**Planning Department
Transportation Development Services**

Re: Wendy's, 3601 4th St. NW
Traffic Circulation Layout
Architect's Stamp dated 07-14-14 (G14-D031)

TRAFFIC CIRCULATION LAYOUT APPROVED

REMODEL/ADDITION SITE PLAN

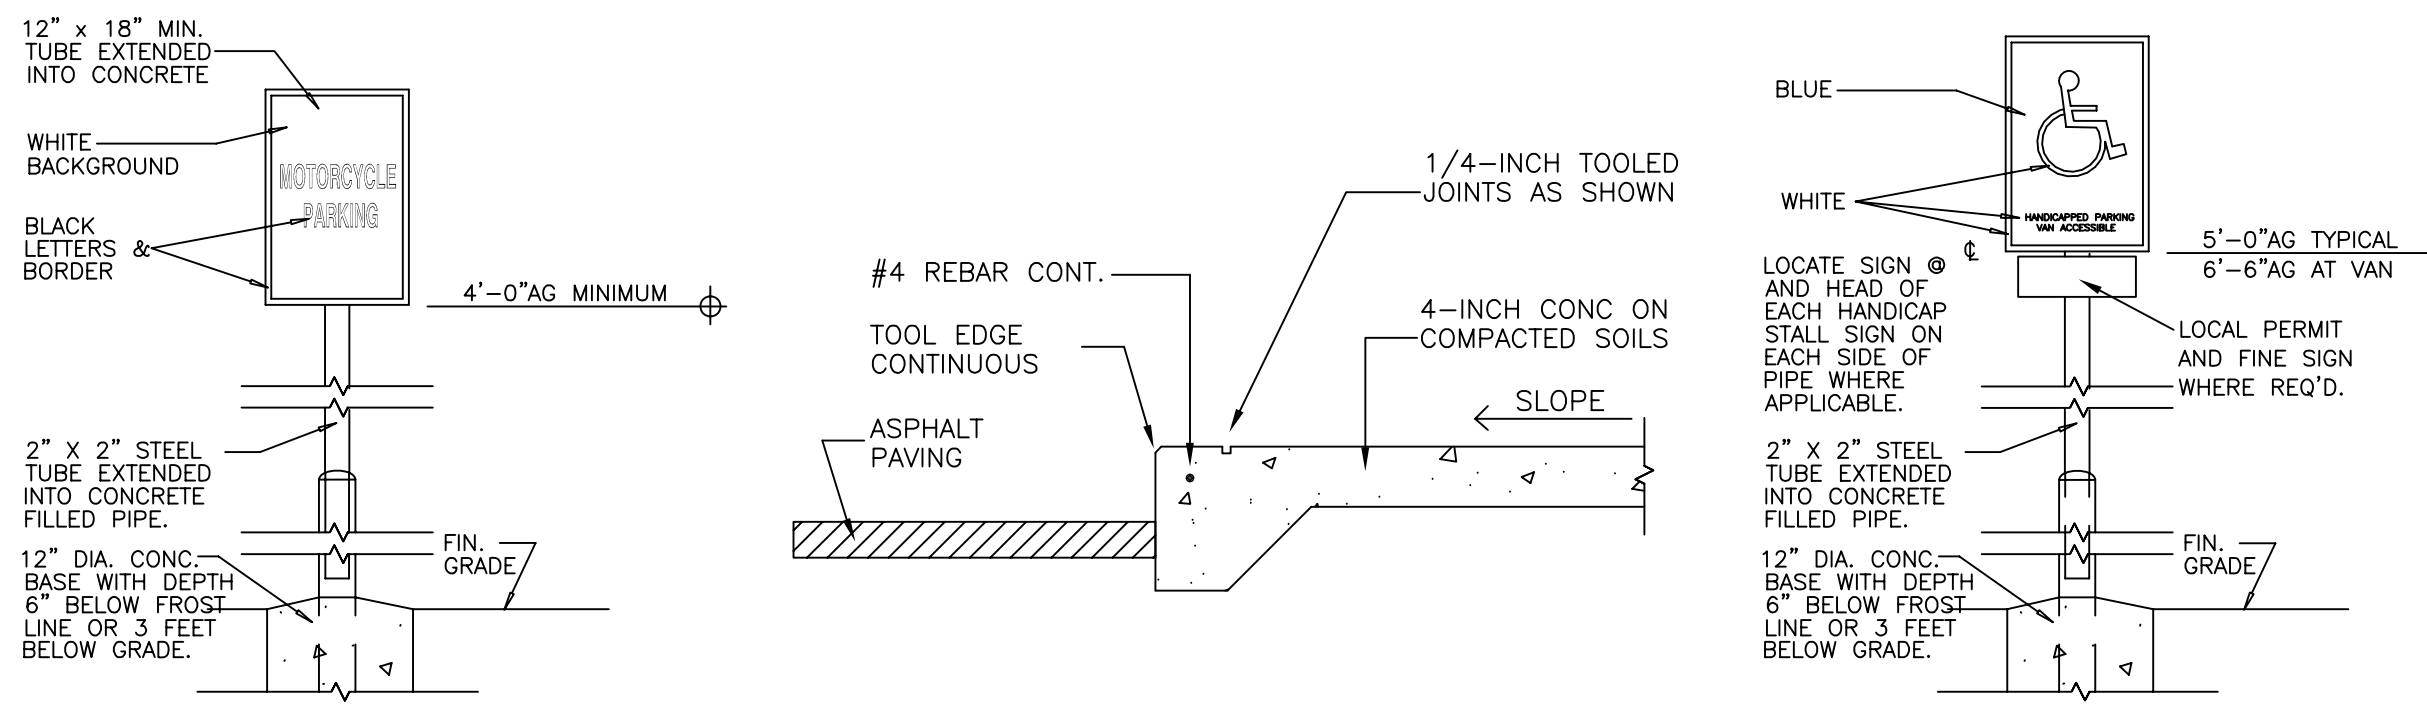
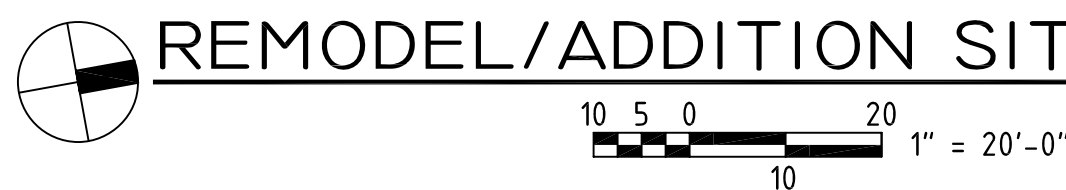
The TCL submittal received 07-14-14 is approved for Building Permit. A copy of the stamped and signed plan will be needed for each of the building permit plans. Please keep the original to be used for certification of the site for final C.O. for Transportation. **Public infrastructure or work done within City Right-of-Way shown on these plans is for information only and is not part of approval. A separate DRC or other appropriate permit is required to construct these items.**

Public Infrastructure shown on these
plans for information only and not part
of an approval. Separate DRC/ Permit
approval and Work Order required.
